**Revision of Manuscript Number:** IEEE-TPWRS-01391-2021, version 1 February 19, 2022

**Journal:** IEEE Transactions on Power Systems

**Author:** Abhishek Halder, Kenneth F. Caluya, Pegah Ojaghi, Xinbo Geng

### Response to decision:

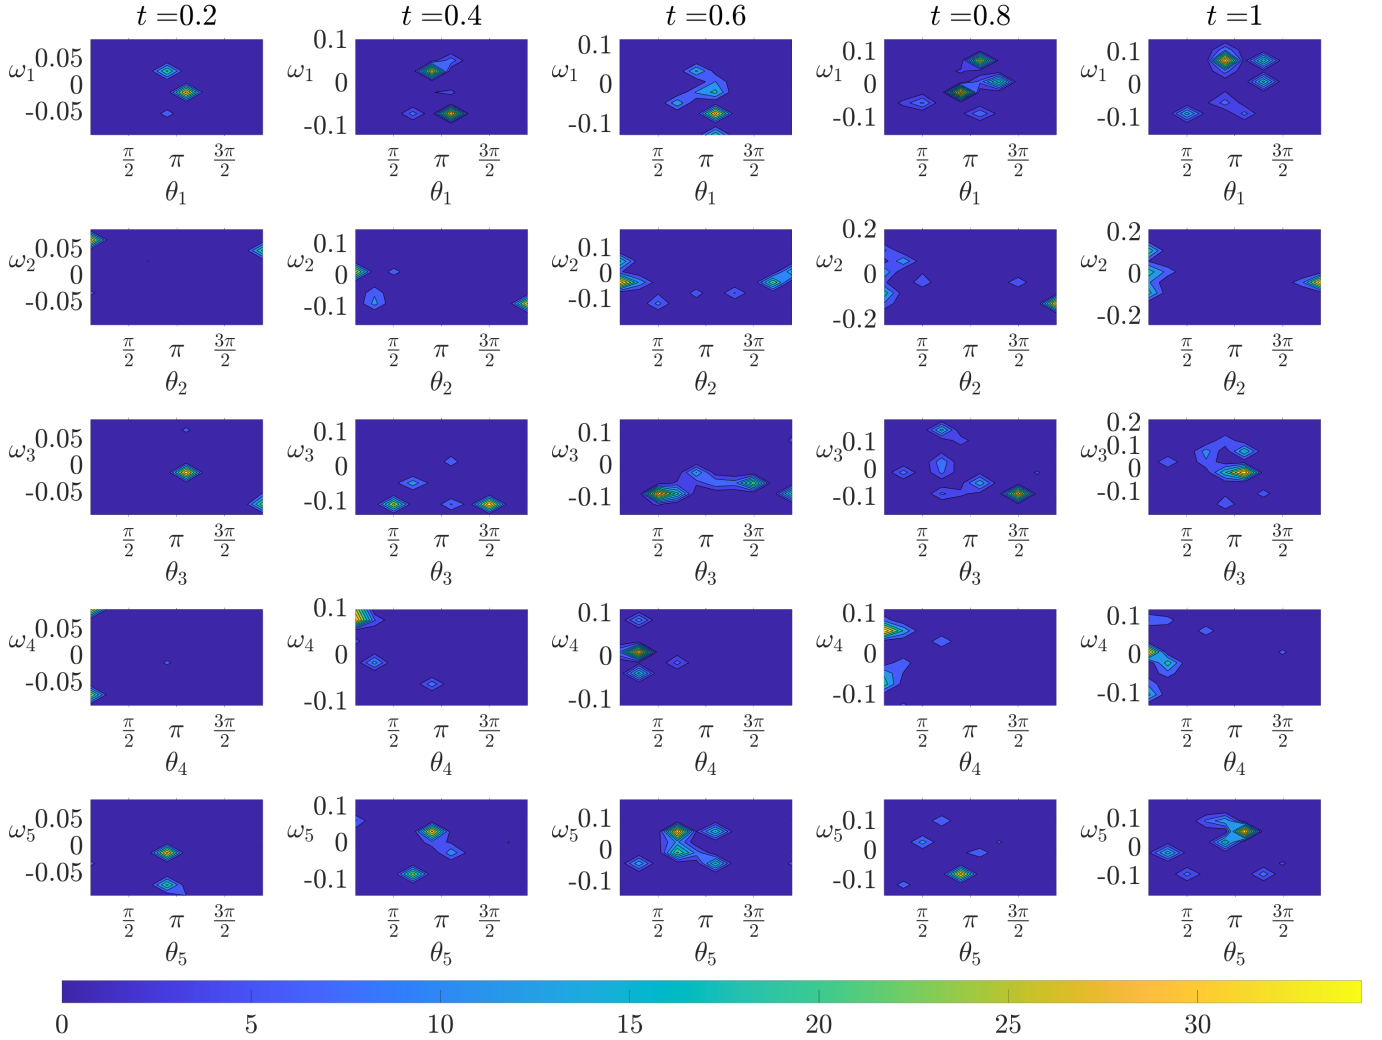
*Figures 5 and 6 are unreadable.*

**Response:** Thanks for this comment. In the previous version, the strict 10 page limit enforced small figure sizes. In the revised manuscript, Figures 5 and 6 are made larger. Also, the Fig. 6 in the revised manuscript shows the transient  $(\theta_i, \omega_i)$  bivariate marginals for all the five generators in Case II; the previous version showed the same only for the generator 4 (bus 6). We believe these changes have improved clarity.

Regarding the style of plots, we had considered plotting the bivariate marginals as planar contour plots (as in Fig. 1 in this rebuttal document) but decided against it because of the following two reasons.

*First*, in our opinion, this kind of plot is scientifically misleading as they hide the fact that these bivariate marginal PDFs are not really supported on the plane, or the subsets thereof, but instead have cylindrical supports. Our message that the proposed method explicitly accounts this manifold geometry in the computation, would be missed had we chosen to make the plots the other way.

*Second*, the planar contour marginal plots require additional mental efforts from the readers to correctly parse the statistical information conveyed. For instance, consider the fourth column, second row subplot in Fig. 1 in this rebuttal document. It is upon the reader to parse that the two high probability regions on the left and right of that subplot are actually referring to the same angular high probability region around  $\theta_2 = 0$  rad, thanks to the periodic boundary condition on the angular variable. Our philosophy of technical communication is that the onus is on the authors, not on the readers, to clarify the scientific information as correctly as possible. We thus prefer to make plots that depict the variables as they are.
